**SUBJECT: Supplemental Geotechnical and Hydrologic Responses to City of Santa Barbara Planning Division Information Request of January 14, 2016**

**RE: 1925 El Camino de la Luz Residential Reuse Project**  
MST#2013-00240, APN: 045-100-024

Site Plan and Geologic Map  
1925 El Camino De La Luz  
APN:045-100-024  
SANTA BARBARA, CALIFORNIA

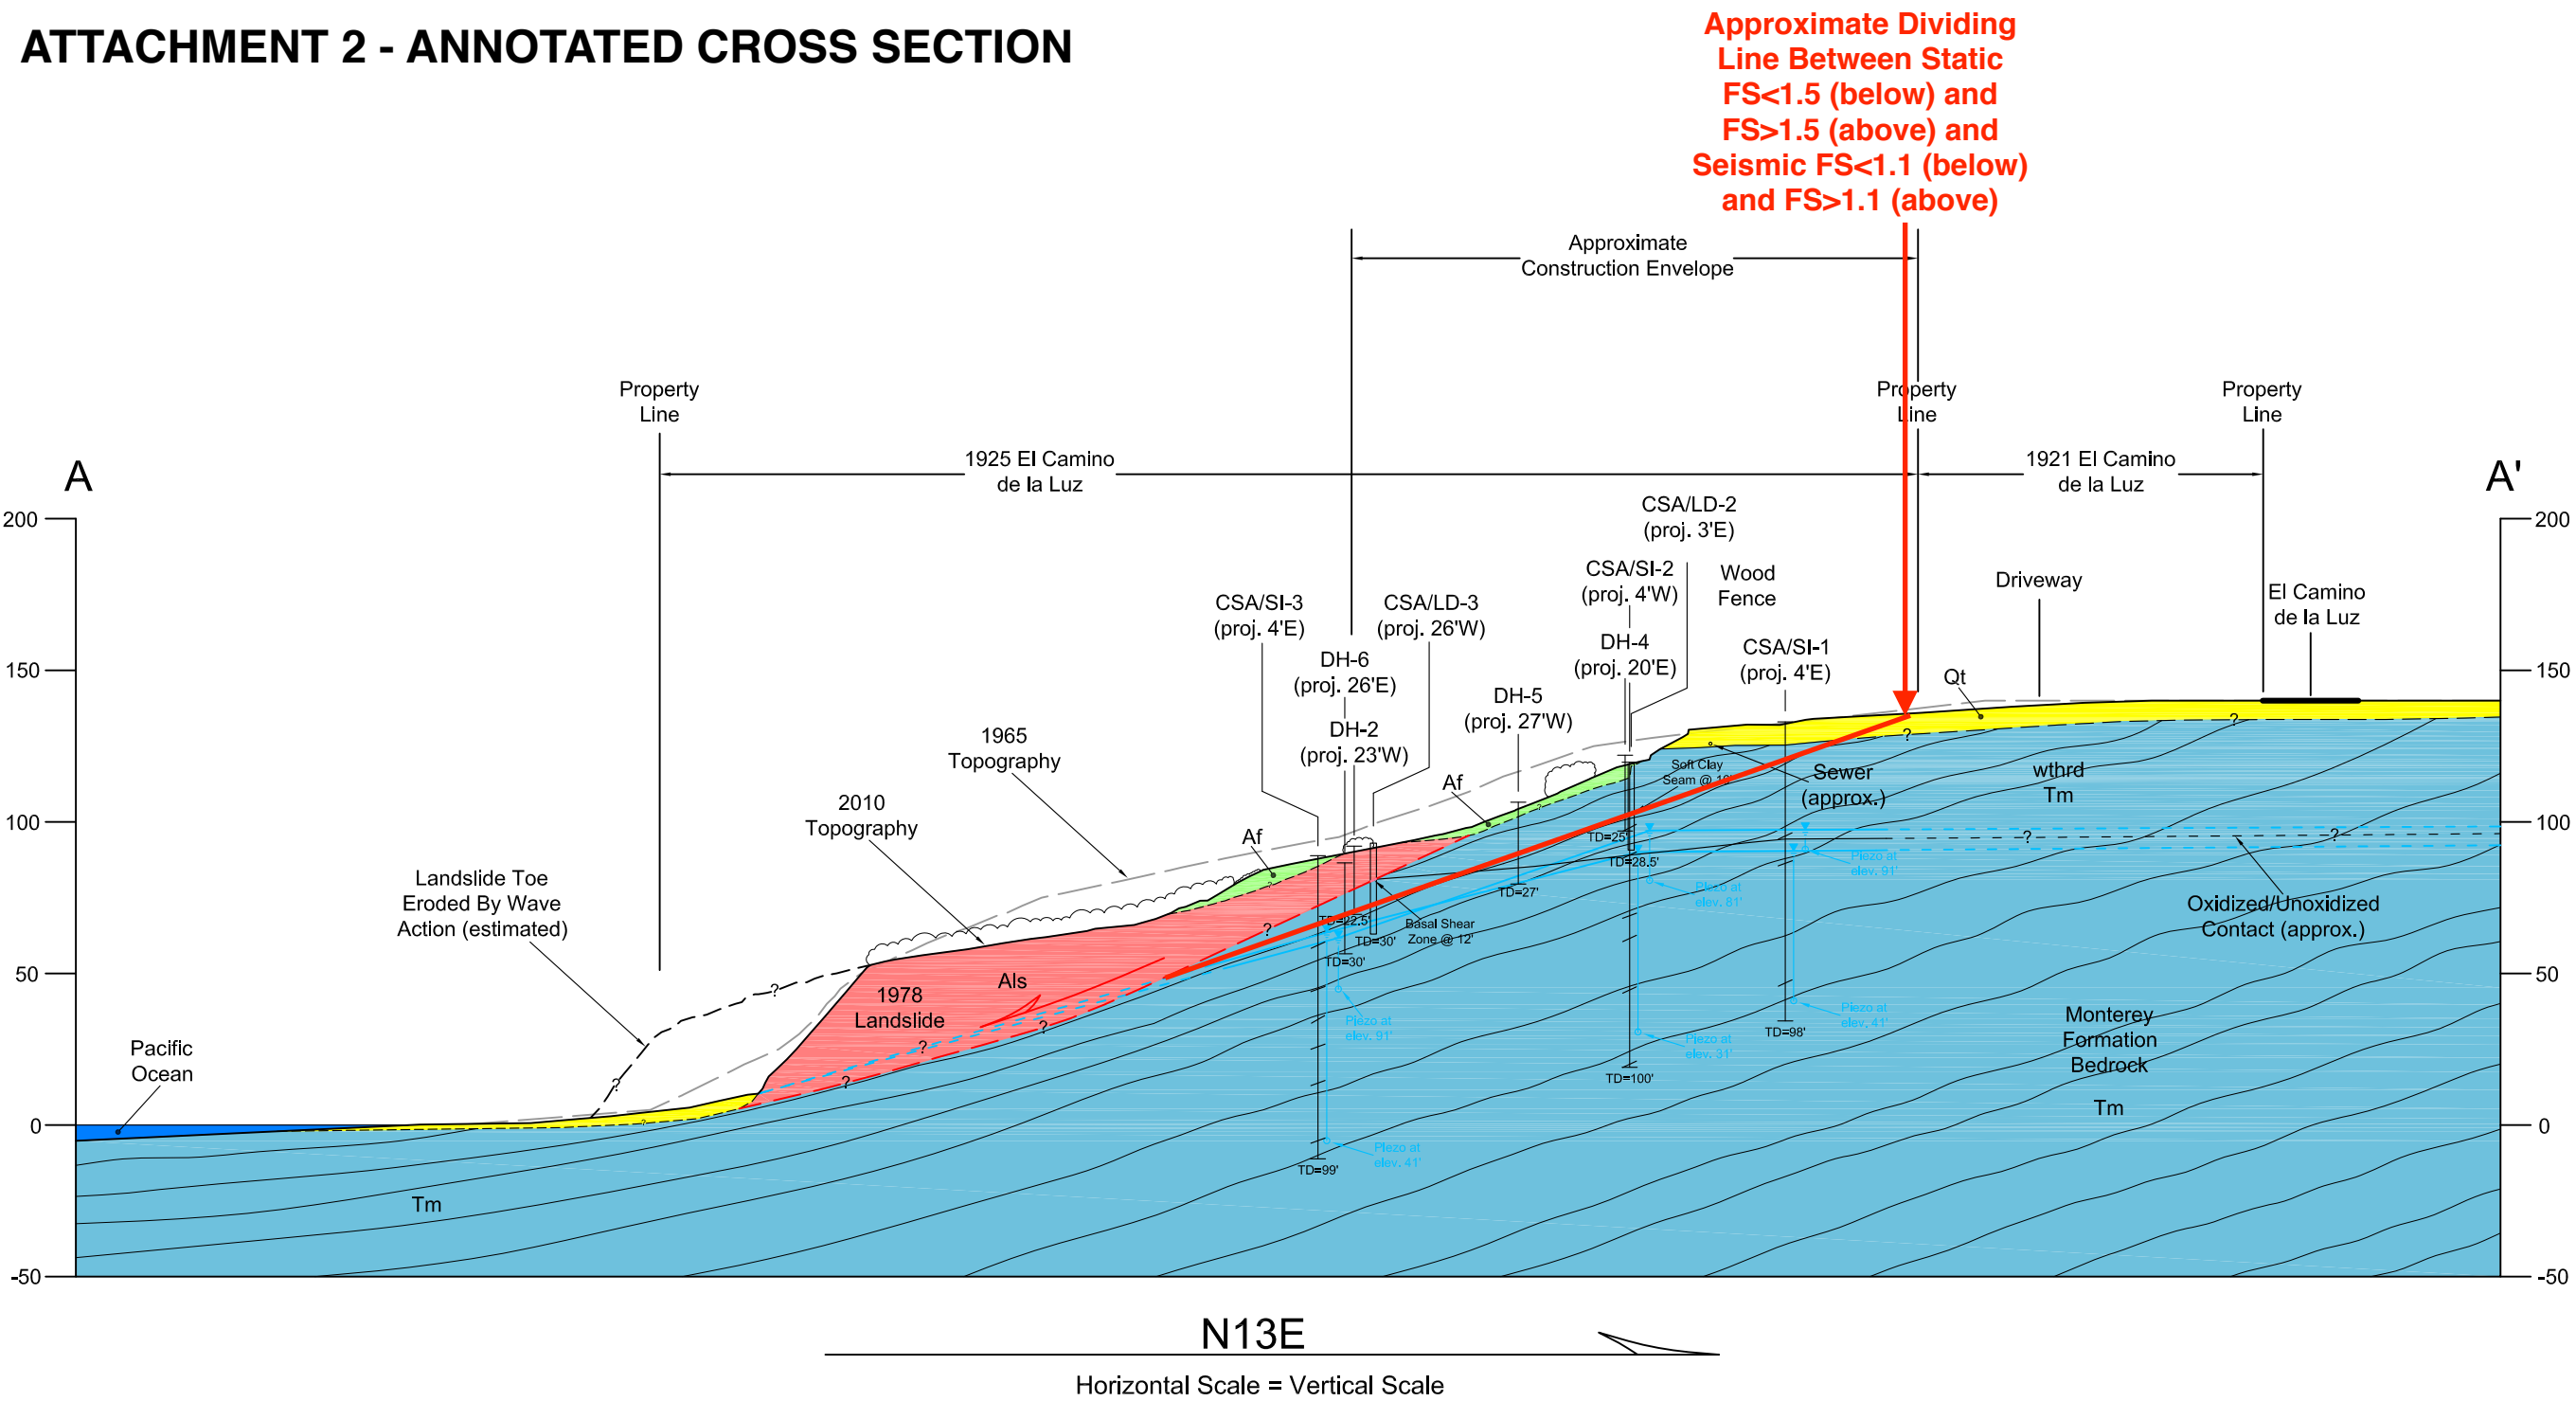
2. *Please confirm the location of the areas considered stable and unstable. In the January 5, 2016 CSA letter, page 2 & 3, it states that the pink areas are considered unstable and all areas above the pink areas are considered stable without the use of slope stability devices. Is this correct?*

The pink area on our engineering geologic map (Attachment 1 to this letter) represents the surface expression of the remaining portion of the 1978 ECDLL landslide on the slope for which we are considering the factor of safety is currently at or near unity for design purposes. Any area upslope of the pink area has a factor of safety greater than unity, which is technically stable, but not stable enough to meet industry standards for new development without stabilization measures. As discussed in our geotechnical investigation report (CSA 2012), the primary engineering geologic constraint at this site is the 'dip slope' bedrock condition, which provides the potential for shallow to moderately deep landsliding to occur in bedrock along weak bedding planes. This dip slope condition results in the southern through central portion of the site having a static safety factor of less than 1.5 (and/or seismic factor of safety of less than 1.1). It should be noted that this condition extends upslope to include the City's Mesa Trunk Line Sewer and a portion of the driveway upslope of the sewer (see Attachment 1 and Attachment 2 to this letter). For new residential development of these portions of the parcel, mechanical, drainage and/or grading improvements are required to achieve a static Safety Factor equal to or greater than 1.5 and seismic factor of safety equal to or greater than 1.1.

Based on slope stability analyses conducted as part of our investigation culminating in our geotechnical report (CSA, 2012), as well as observations made from our subsurface exploration (including a soft clay seam [bedding feature] at a depth of 16 feet in boring CSA/LD-2 – see Attachment 2), the area requiring stabilization measures for safe new and appurtenant development includes the 1925 ECDLL proposed development envelope, as shown on the project site plan (ABDS, 2015), up to the dividing line shown on the driveway on Attachment 1 (Annotated Map [base previously Figure 5, Site Plan and Geologic Map, of the CSA 2012 geotechnical report]) and Attachment 2 (Annotated Cross Section [previously Figure 6, Engineering Geologic

Cross Section A-A', of the CSA 2012 geotechnical report]) to this letter. Consequently, our response on pages 2 and 3 of our January 5, 2016 letter should be deemed clarified accordingly.
